PROJECT: KYLE CANYON MASTER DRAINAGE STUDY
(AKA. SKYE CANYON MASTER DRAINAGE)

SUBMITTAL: 5TH

MASTER DRAINAGE STUDY
RESPONSE TO NDOT COMMENTS

Subject: Response to NDOT Comments on the Master Drainage Study for Kyle Canyon (CLV DS4420, NDOT Advance Drainage Study No. 246)

2008
LAS VEGAS VALLEY
FLOOD CONTROL
MASTER PLAN UPDATE
FIGURE F- 8
FLOOD CONTROL FACILITIES

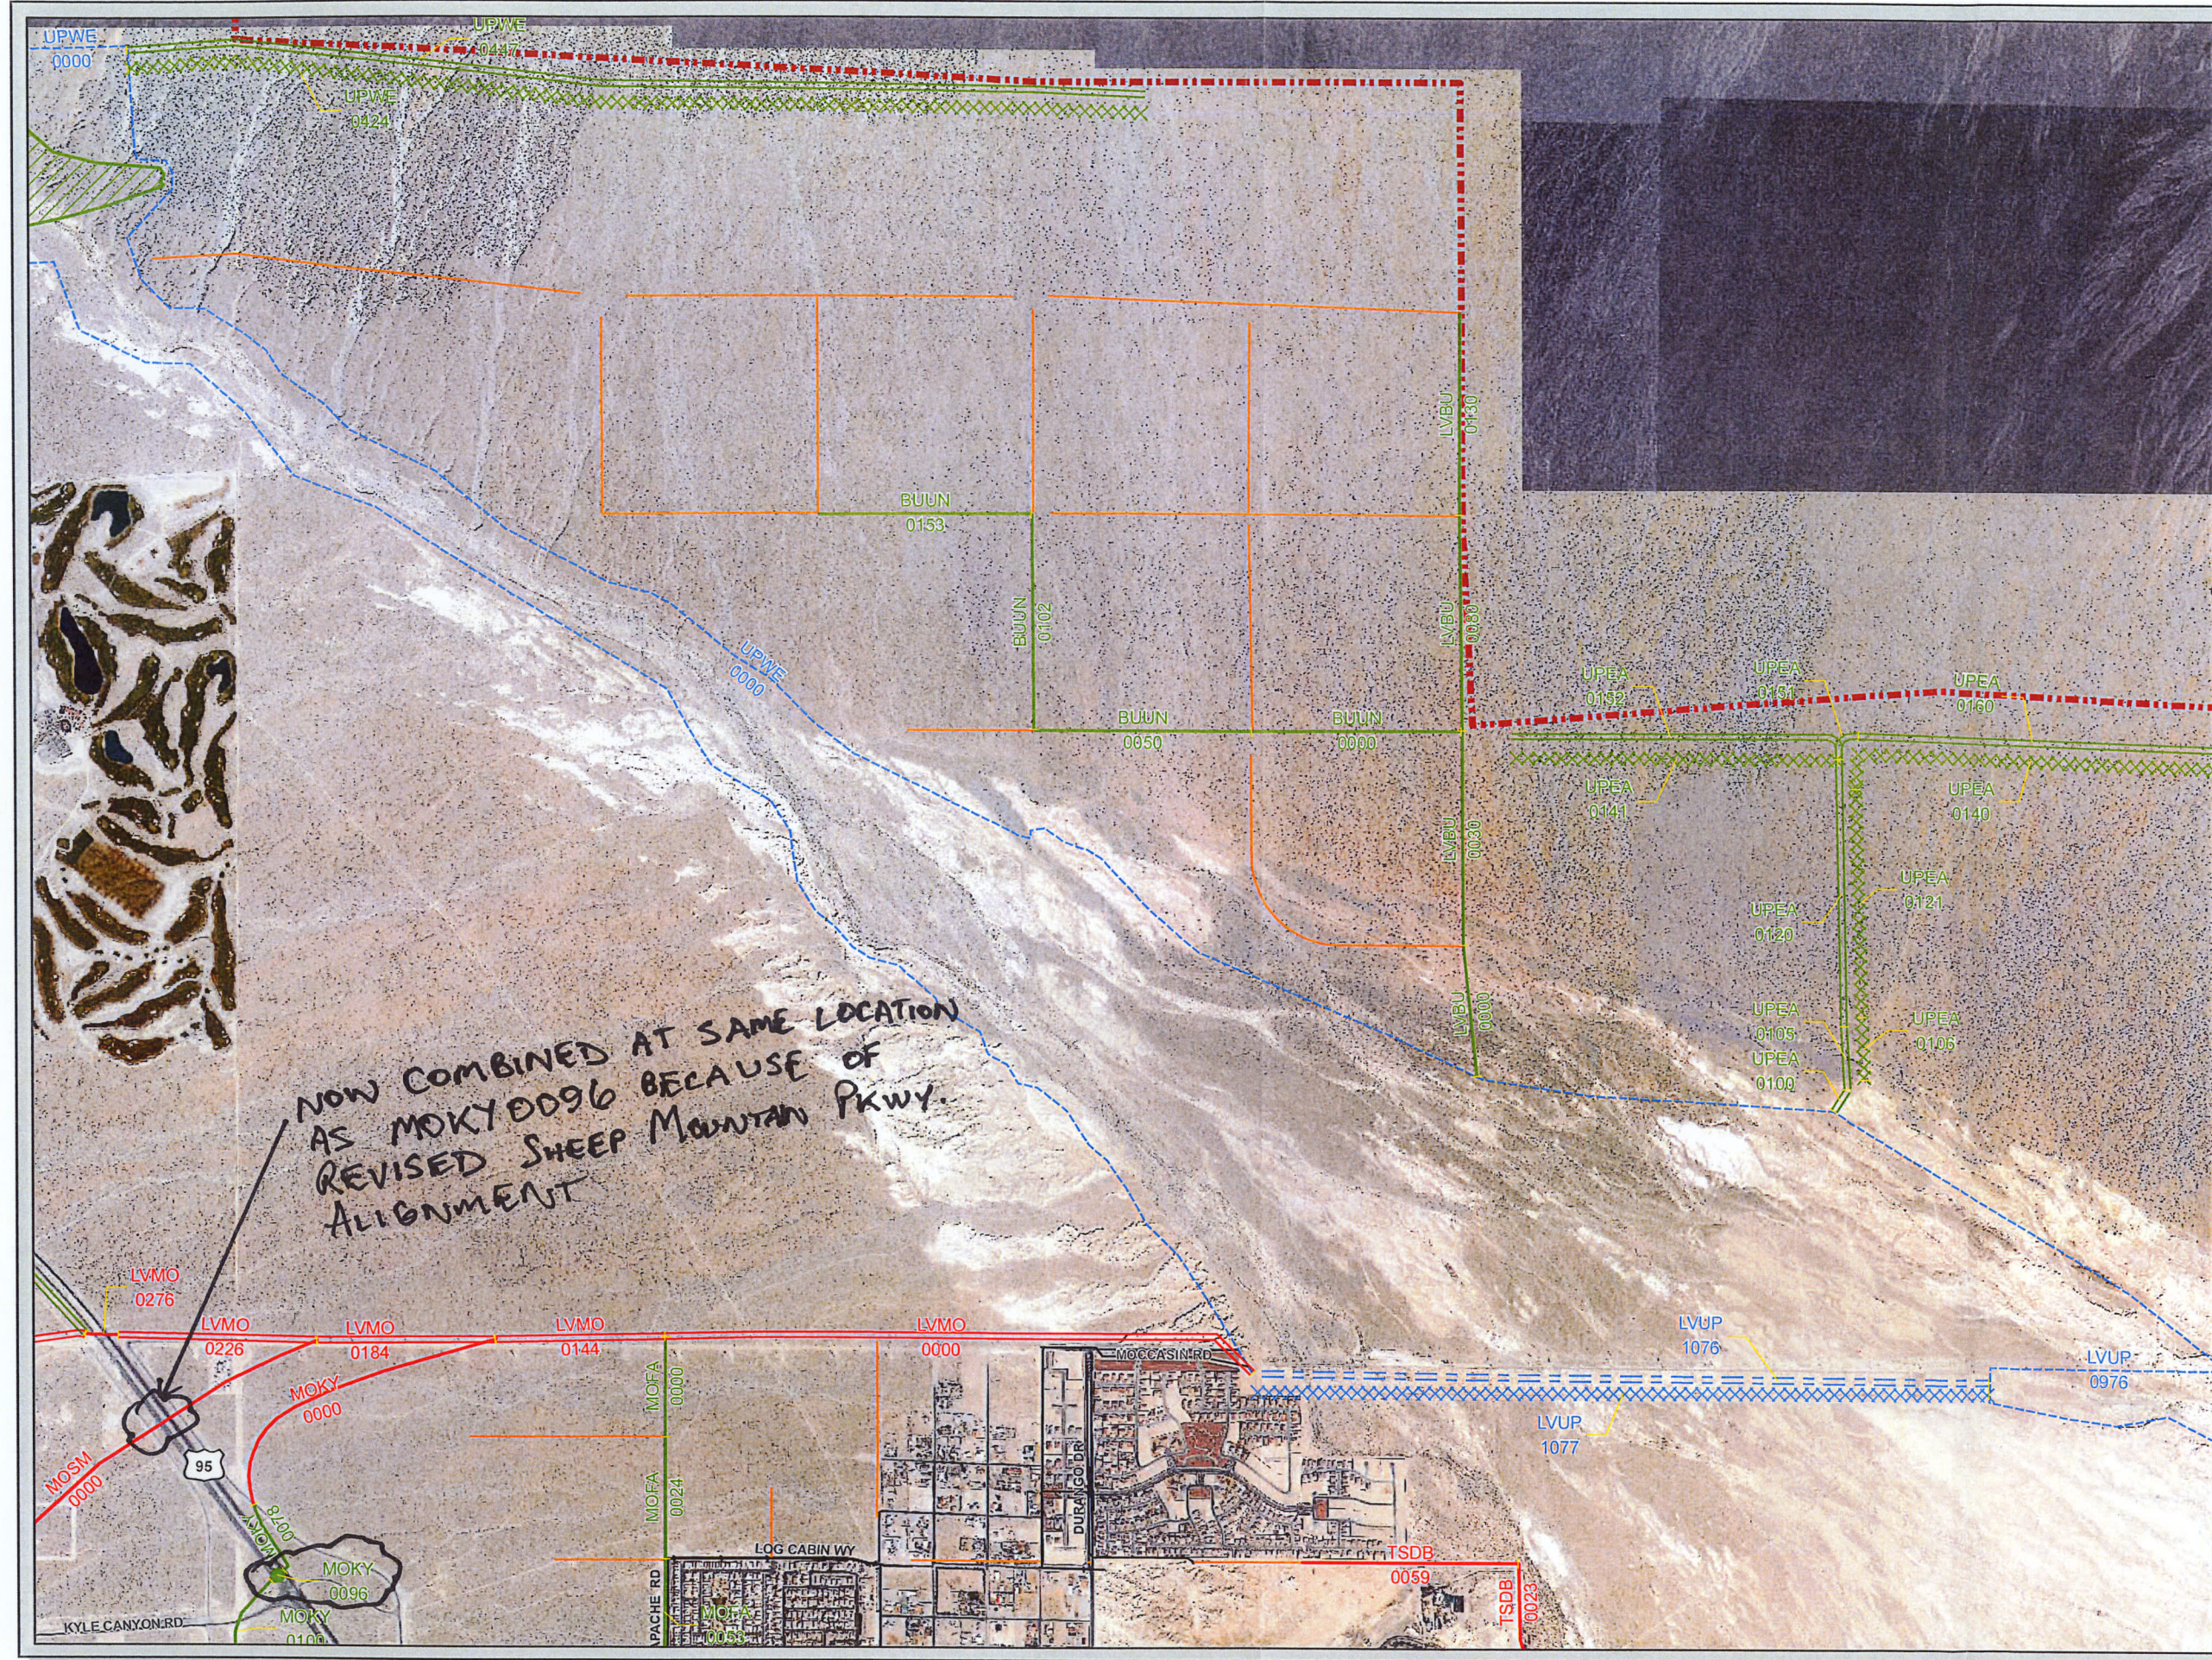
2. **Comment:** *Before you read this comment, I do want to say that I recognize that CCRFCF has already given their approval on the Technical Drainage Study. In comparing the 2008 CCRFCF Master Plan Update (MPU), there are some differences between the proposed layout and the MPU. The main concern rests upon the more than doubling of flow at the future interchange with Kyle Canyon (from 1066 cfs to a proposed 3324 cfs), while at the same time shrinking the proposed facility to about half (from double 13-ft by 7-ft RCB to a proposed single 14-ft by 8-ft RCB);*

2) Before you read this comment, I do want to say that I recognize that C.C.R.F.C.D. has already given their approval on the Technical Drainage Study. In comparing the 2008 C.C.R.F.C.D. Master Plan Update (MPU), there are some differences between the proposed layout and the MPU. The main concern rests upon the more than doubling of flow at the future interchange with Kyle Canyon (from 1066 cfs to a proposed 3324 cfs), while at the same time shrinking the proposed facility to about half (from double 13'x 7' RCB to a proposed single 14'x8' RCB).

NOW COMBINED AT SAME LOCATION
AS MOKY 0096 BECAUSE OF
REVISED SHEEP MOUNTAIN PKWY.
ALIGNMENT

Response: In regards to the difference in flow rates between the 2008 MPU and the current SHG Master Drainage Study, the proposed flow rate at the Kyle Canyon interchange is different because of site plan differences. It was previously assumed that CLV Sheep Mountain Parkway would be aligned along the western boundary of the site, future Sheep Mountain Parkway would convey flow in the future Kyle Canyon regional facility MOKC 0222 (2,192 cfs), and cross US-95 further north than Kyle Canyon Road. The current site plan provided in the SHG Master Drainage Study assumes Sheep Mountain Parkway bisects the property and intersects with the US-95/Kyle Canyon interchange. Therefore, the flow in regional facility MOKC 0222 combines in the proposed Kyle Canyon crossing of US-95. Arithmetic addition of regional facilities MOKY 0096 (1,066 cfs) and MOKC 0222 (2,192 cfs) results in a flow similar to the design flow (3,324cfs) utilized in conceptually sizing the proposed facility crossing US-95 at the Kyle Canyon interchange.

In regards to the size discrepancy of the storm drain facility shown crossing US-95 at the Kyle Canyon interchange, based on the CCRFCF MPU legend, MOKY 0096 has been conceptually assumed as a culvert crossing; whereas, the size of the proposed SHG facility assumes connectivity of the storm drain crossing US-95 and that it will not function as a culvert crossing. By assuming the facility at the interchange is a culvert crossing, the 2008 MPU artificially increases the size of the facility based on bridge criteria outlined in the MPU and the CCRFCF Manual.

Referenced facilities figures from the 2008 MPU have been included in the appendix for further support of the above discussions. It is noted that the proposed facility crossing US-95 is only conceptually designed with this study and a detailed technical analysis is required in order to construct the facility (including verification of longitudinal slopes and further hydraulic analysis).
